From: "Peter MacLaggan" <pmaclaggan@poseidon1.com>
To: "Chiara Clemente" <CClemente@waterboards.ca.gov>
CC: "Brian Kelley" <BKelley@waterboards.ca.gov>, "David Barker" <DBarker...>
Date: 4/30/2008 4:13 PM
Subject: RE: Poseidon's CDP Plan - questions regarding IM & E assessments
Attachments: RWQCB Staff Question and response 043008.doc

From: Chiara Clemente [mailto:CClemente@waterboards.ca.gov]
Sent: Thursday, April 17, 2008 9:48 AM
To: pmaclaggan@poseidon1.com
Cc: Brian Kelley; David Barker; Deborah Woodward; Mike McCann
Subject: Poseidon's CDP Plan - questions regarding IM & E assessments

1. ENTRAINMENT

Figure 1.

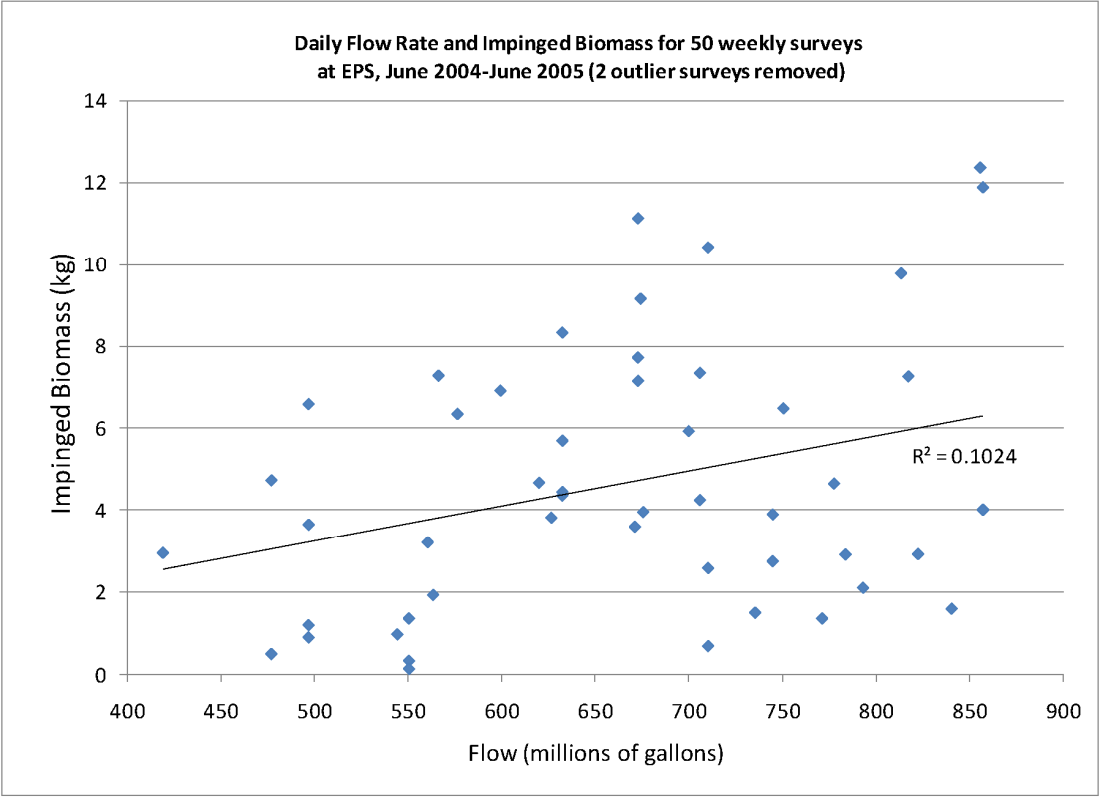
RWQCB Comment: Based on our review of the impingement assessment in the Plan, it appears that the daily biomass of impinged fish (0.96 kgs/day) may have been incorrectly calculated.

(a) Attachment 2 appears to present counts and weights of impinged organisms found during each of the 24-hour sample events conducted weekly from June 24, 2004 through June 15, 2005, i.e., 52 sample events, each representing 24-hour impingement;

(b) Table 5-1 appears to present - not annual count and weight totals prorated to 304 MGD as indicated by the caption - but rather line totals (by taxa) of the counts and weights from Attachment 2, i.e., Table 5-1 appears to present 52-day totals with no adjustment for flow on the day of sampling, no interpolation for the days between sample events, and no prorating to 304 MD; and,

(c) therefore, calculation of the daily biomass of impinged fish by dividing the un-interpolated, un-prorated Table 5-1 total weight (351,672 grams) by 365 days appears to be in error.

Response: The weights and taxa collected during the 52 week samples shown in Table 5.1 are correct. Therefore, the total amount of impinged species collected over the 13-month sample period of 3,651,179 grams (3,651.179 kg) is accurate. However, staff is correct that there is an error in the calculation used to convert this information to a daily amount.

In response to staff's request, we have revised the estimate of the daily impingement effect of the intake operations. Figure 1 (below) shows the average daily flow rate and impinged biomass for 50 of the 52) weekly surveys collected during the impingement survey period. The two remaining samples were outliers and therefore were not included in the analysis in order to get more accurate statistical correlation of the impingement results.

As shown in Figure 1, the sampling period flow rate consistently exceeded the stand-alone desalination plant flow of 304 MGD. However, from this information we are able to extrapolate an average daily impingement effect of 1.56 kg the desalination plant stand-alone operations at 304 MGD using the statistically significant relationship between the impingement effects and flows measured under normal power plant operations that occurred during the June 2004 to June 2005 impingement survey.

It is important to note that 6 of the 13 samples collected for plant intake flows at or below 550 MGD had impingement effect approximately equal to or less than the initially estimated daily impingement effect 0.96 kg/day. Another trend that can be noted in Figure 1 is that the opposite is true for flows above 550 MGD -- the majority of the impingement results are above the average of the curve.

This observation is consistent with other nationwide findings on the relationship of intake volume, velocity, and impingement that indicate an impingement effects threshold at or above a velocity of approximately 2 fps. Below this velocity, impingement effects decline rapidly. The impingement effects continue to dramatically decline as the intake approach velocity nears 0.5 fps and below. The desalination plant stand-alone operations at 304 MGD will mirror these conditions -- intake approach velocities at bar racks will be approximately of 0.5 fps. Consequently, we expect to observe a velocity driven impingement reduction effect that will result in actual impingement rates that are below the statistical projection of 1.56 kg/d and possibly below 1.0 kg/d.

Although the estimated daily impingement rate of 1.56 kg/d is slightly higher than previously indicated, the total amount of impinged species collected over the 13-month sample period of 3,651,179 grams is unchanged. This level of impingement, along with the adjusted daily estimate continues to represent a *de minimis* impingement effect.
